RICKENBACKER AIR NATIONAL GUARD BASE  
COLUMBUS, OHIO

ADDITIONAL SITE INSPECTION SAMPLING  
ADDENDUM #1 TO SI/RI/FS/RD WORK PLAN

FINAL

OCTOBER 1989

**FIGURE 2.1**

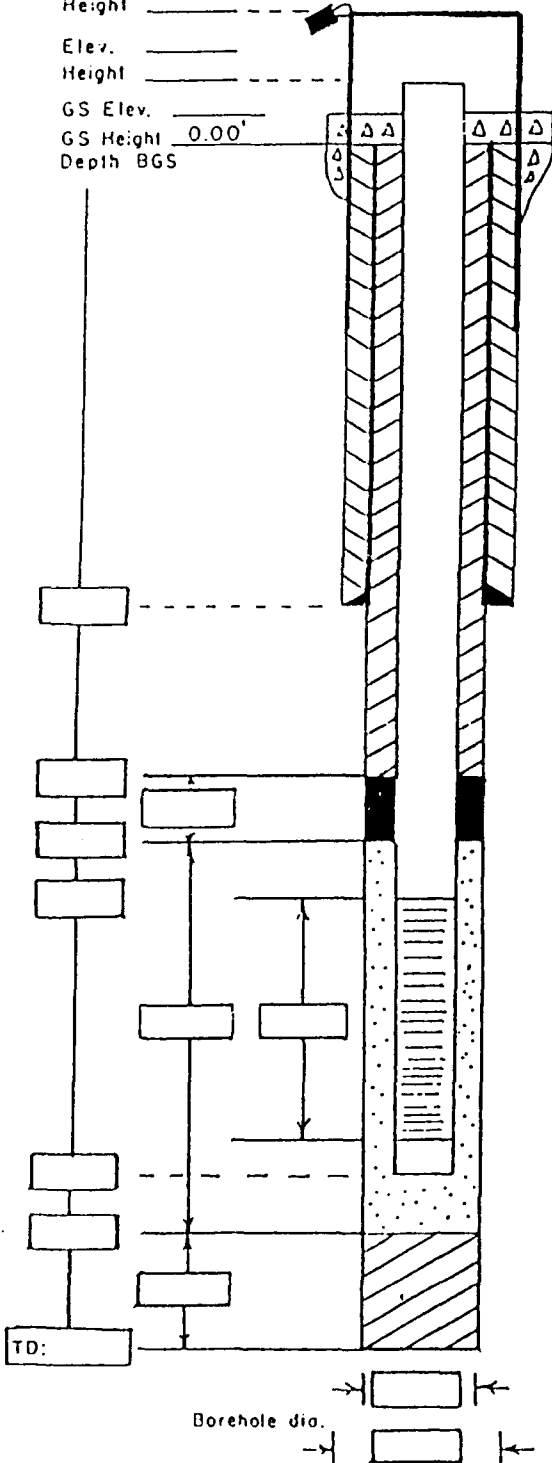
The second modification involves increasing the documentation for monitoring well construction. The HAZWRAP monitoring well construction log shown as Figure 2.1 will now be used in all reports.
